ADDENDUM NO. 1

2017 Baxter Lane Improvements Project Bozeman, Montana

Date of Addendum: August 1, 2017
Bid Opening Date: August 15, 2017 at 2:00 p.m.

This addendum modifies the Contract Documents and Construction Drawings for the 2017 Baxter Lane Improvements Project from Cottonwood to Ferguson in Bozeman, Montana, as set forth herein:

CITY OF BOZEMAN STANDARD DRAWING	Date: 2016-08-05	TYPICAL FRANGIBLE TYPE TRANSFORMER BASE DETAIL	FIGURE 16
	Scale: N.T.S.

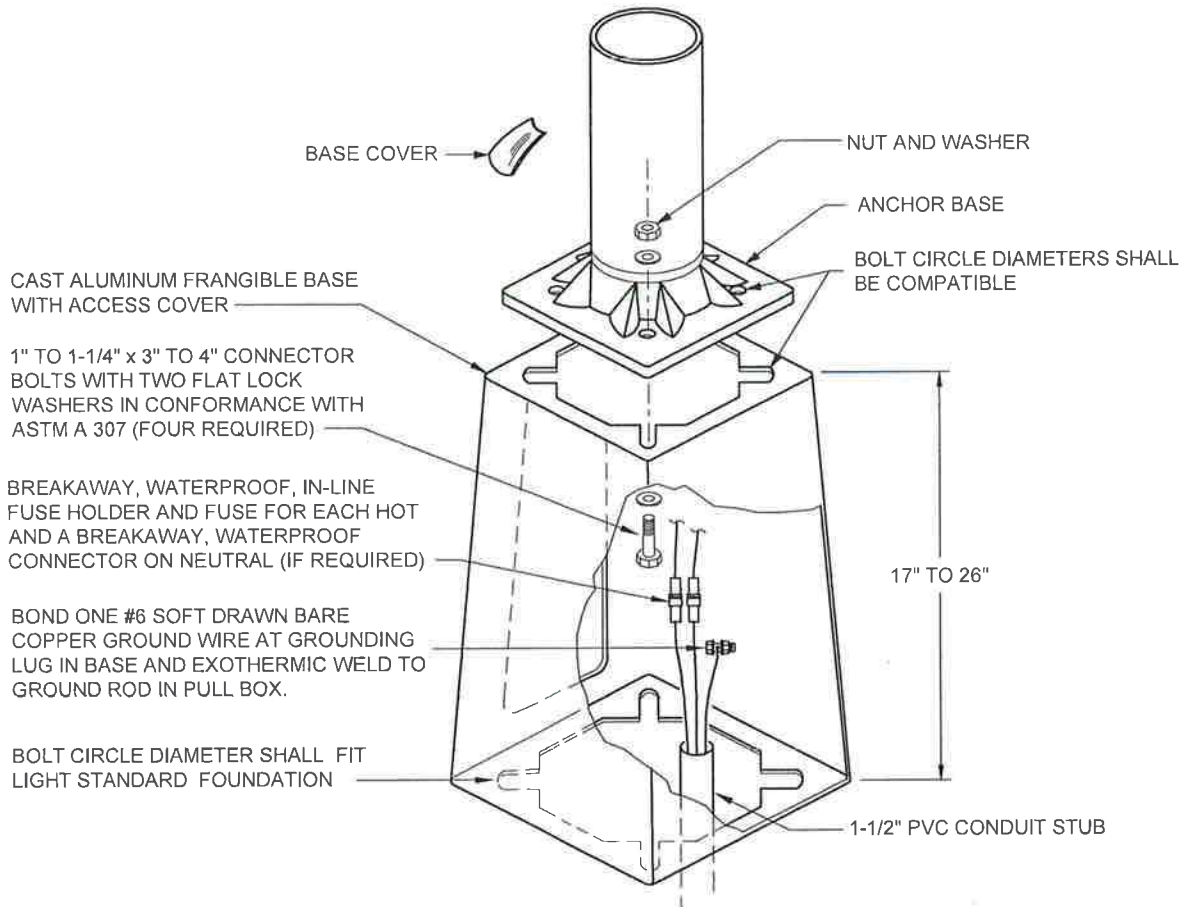
Sheet E-3:

Replace the detail for “BREAK AWAY TRANSFORMER BASE” with the attached City of Bozeman Standard Drawing “FIGURE 16, TYPICAL FRANGIBLE TYPE TRANSFORMER BASE DETAIL”.
